Service Bulletin

Number: 0019

Title: Fuse Correction

Product Identification: PCNC 1100 Milling Machine, serial numbers 1 through 1181.

Figure 3 - Location of FU3 on Circuit Diagram

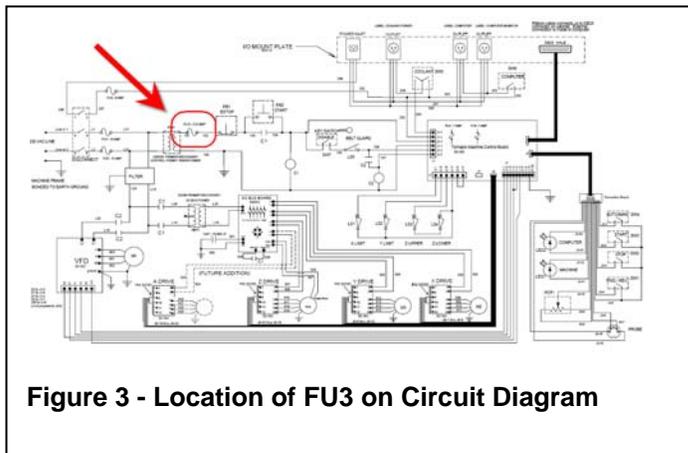
2. Correct the fuse specification in the operator's manual. The electrical parts list and circuit diagram is in section 10 of your owner's manual. Figure 3 shows the location of the fuse specification on the circuit diagram. You can make a notation on the existing circuit diagram or mark out the diagram and insert a revised copy in your manual.

FU3 was originally specified and installed as a 6 Amp fuse. It should be 0.6 Amp. If a component or wiring failure were to occur the normal mode of failure should be a blown fuse. In this case fuse FU3 is in the 115 VAC control power circuit, downstream of the control power transformer (XFM1). When the fuse specification is too large it will not properly protect the control power transformer and an overload would likely lead to a failure of the transformer instead of a blown fuse. To correct this problem FU3 must be replaced with a 0.6 Amp fuse.
